28th February 2017

**Re: CLEARY BROS. ALBION PARK QUARRY – STAGES 5 & 6 MODIFICATION
LEC CONSENT NO. 10639 OF 2005 MOD 3
FURTHER RESPONSE TO MATTERS RAISED IN UPDATED SUBMISSIONS**

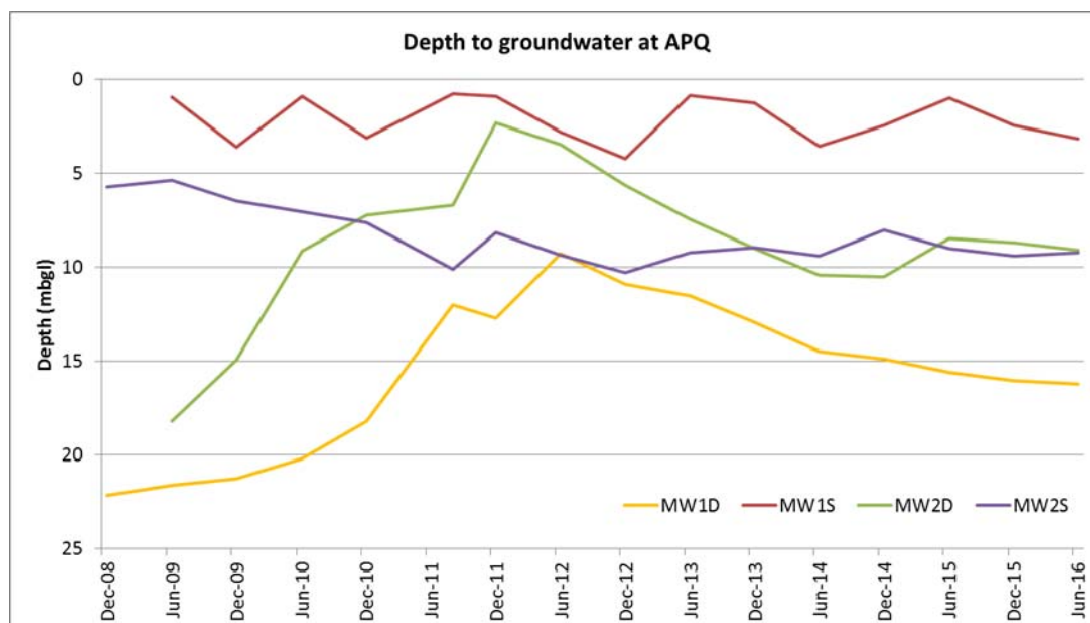
In accordance with our previous submission, groundwater interception in the earlier stages of the quarry development has been minimal, with the massive basalt structure containing little free water. Quarrying is restricted to this hard rock resource overlying the porous sandstone aquifer. Water levels recorded in the

groundwater monitoring bores, combined with the observable minimal accumulation of water in the Quarry Extension sump outside of rainfall events, suggest that there has been negligible interception of groundwater by the Quarry Extension to date.

Water is discharged from this sump in the quarry pit (as required) to the creek located to the south in accordance with *Environmental Protection Licence 299*, or to assist in watering of the revegetation and rehabilitation areas. The levels in the two groundwater bores that are located outside the extraction area are tested biannually and are included in the proponent's Annual Review (which is available on their web page).

Water is not currently taken for other operational uses as the main storage pond located to the north-west of the quarry extension currently has sufficient capacity. Should this change in the future, the proponent will seek to apply for any necessary approvals under the *Water Management Act 2000*.

For further clarification with respect to groundwater disposal, the Quarry Environmental Management Plan (QEMP, which formed part of the EA submission) describes the methods of removing surplus water (including surface runoff and any groundwater that may be intercepted) from the Quarry Extension. The QEMP states "When collected water is available, water is to be periodically released from the quarry to the creek system to mirror natural pre-quarry flows". It also states: "Collected water is to be reinjected to groundwater should monitoring show that groundwater levels are declining as a result of quarrying" (emphasis added).
